**CITY OF FLORENCE  
PLANNING COMMISSION**

**RESOLUTION PC 15 11 DR 02**

A REQUEST FOR A CHANGE OF USE AND DESIGN REVIEW TO CREATE A CHILDREN’S THEATER, CONSISTING OF AN INTERIOR REMODEL OF THE 3,120 SQUARE FOOT BUILDING AND THE ADDITION OF EIGHT PARKING SPACES, EXTERIOR LIGHTING, LANDSCAPING AND STORMWATER SWALES AS WELL AS A FUTURE EXTERIOR COVERED STORAGE SPACE AT THE REAR OF THE BUILDING.

**STAFF REPORT & FINDINGS OF FACT  
FLORENCE COMMUNITY DEVELOPMENT DEPARTMENT  
Planning Commission  
Exhibit "A"**

SITE PLAN

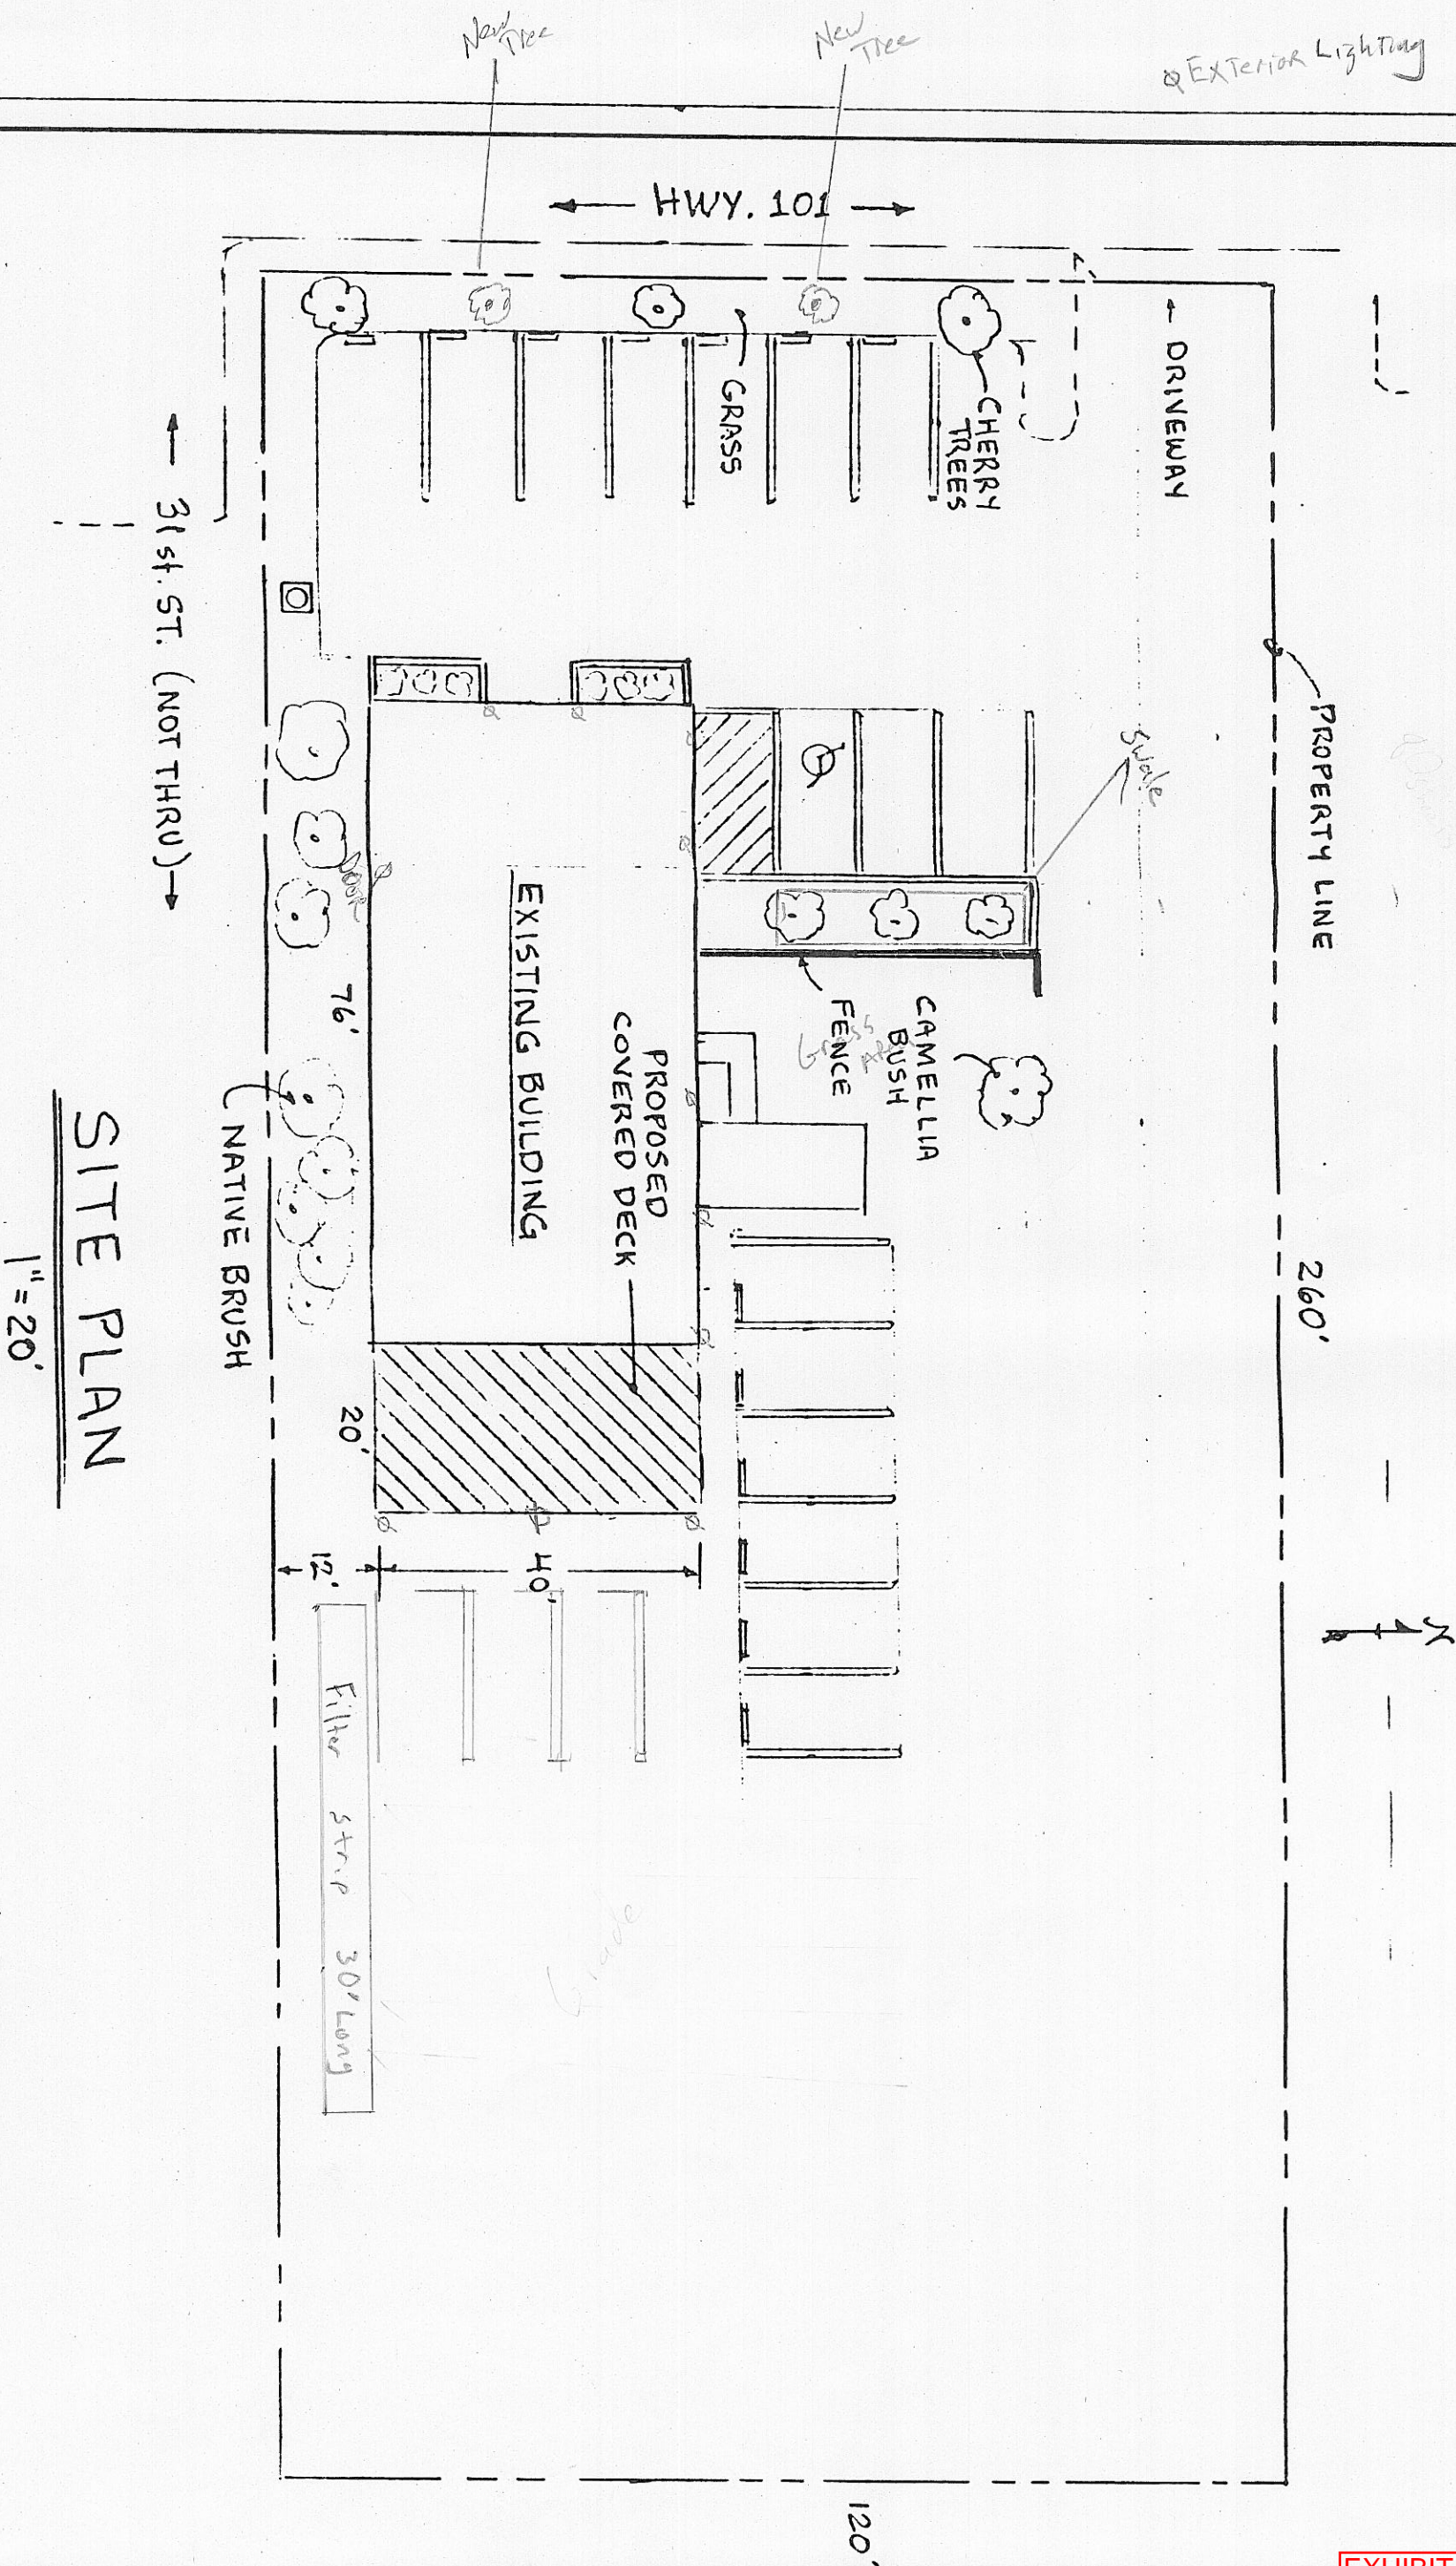
The applicant has proposed to provide one ADA van-accessible parking space at the front of the building. The submitted site plan indicates that the ADA access aisle will be a 96" aisle van-accessible space. The proposed ADA parking space meets this criterion.

The applicant has provided a parking plan showing the individual parking spaces proposed and the access to Highway 101. The applicant will be required to provide drainage for their added impervious surface in the form of a driveway and additional parking from the existing driveway to the rear of the building. The applicant should refer to FCC 9-5 for more information.

The applicant has submitted a parking plan. The plan submitted does not indicate whether the space striping meets the requirements of FCC 10-3-9 with regard to double line striping and stripe width. Motor vehicle spaces, including existing motor vehicle spaces, shall meet the requirements of FCC 10-3-9. Existing spaces shall meet the criteria of FCC 10-3-9 when the lot is resurfaced, resealed, or restriped. **(Condition 3.6)**

The applicant shall provide a building permit application with exact dimensions of the area to-be paved as well as the curb cut dimensions, grading and drainage details, and specifications for signage of the ADA accessible parking space. **(Condition 3.5)**

The applicant shall provide internal sidewalks in all new areas of paving (north and east sides) in order to protect pedestrians from vehicular traffic and provide a safety separation between the building and parking spaces. The pedestrian area may be separated from the parking spaces by a raised curb or by wheel stops. **(Condition 7.3)**
